MARK	DATE	DESCRIPTIONS	BY	CH'D	CCO#
2	06/13/08	BARRIER MODIFICATIONS	GB	TH	44
1	08/24/07	BARRIER MODIFICATIONS	GB	TH	44

CONTRACT CHANGE ORDER NO. ____
SHEET ___ OF ___

SAN FRANCISCO OAKLAND BAY BRIDGE
EAST SPAN SEISMIC SAFETY PROJECT
SELF-ANCHORED SUSPENSION BRIDGE (SUPERSTRUCTURE & TOWER)

LUMINAIRE SUPPORT DETAILS NO. 1

ELEVATION
WELDED LUMINAIRE SUPPORT BOX
1:10
(WB Shown, EB similar) (See Note 12)

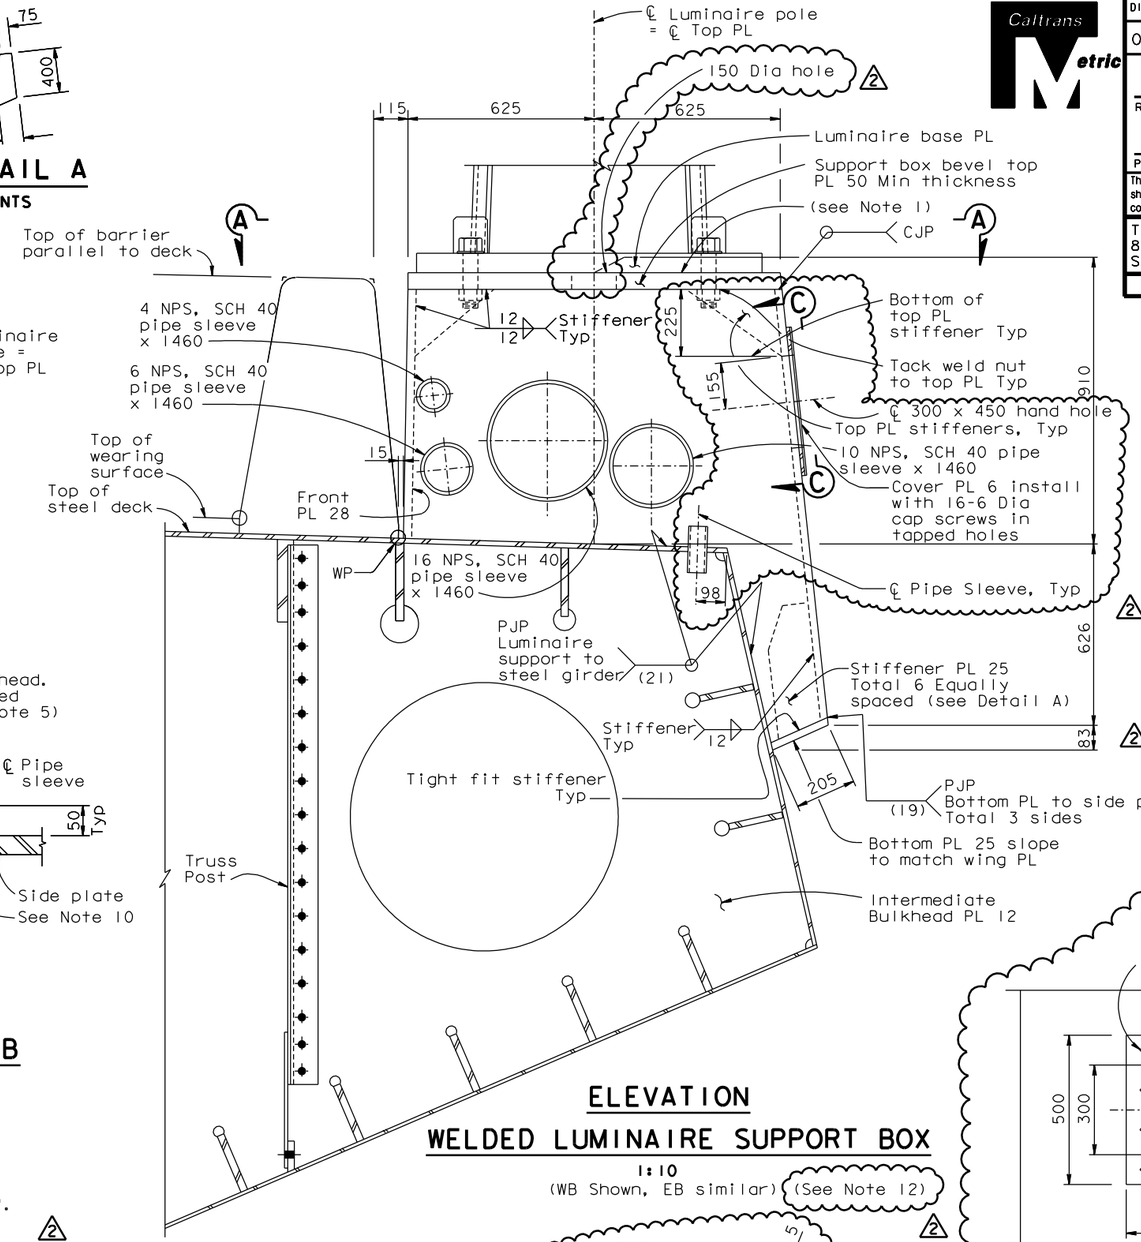
12. At locations where cable railing interferes with luminaire support box, terminate railing at eye bolts, each side of support box, subject to review and approval of the Engineer.
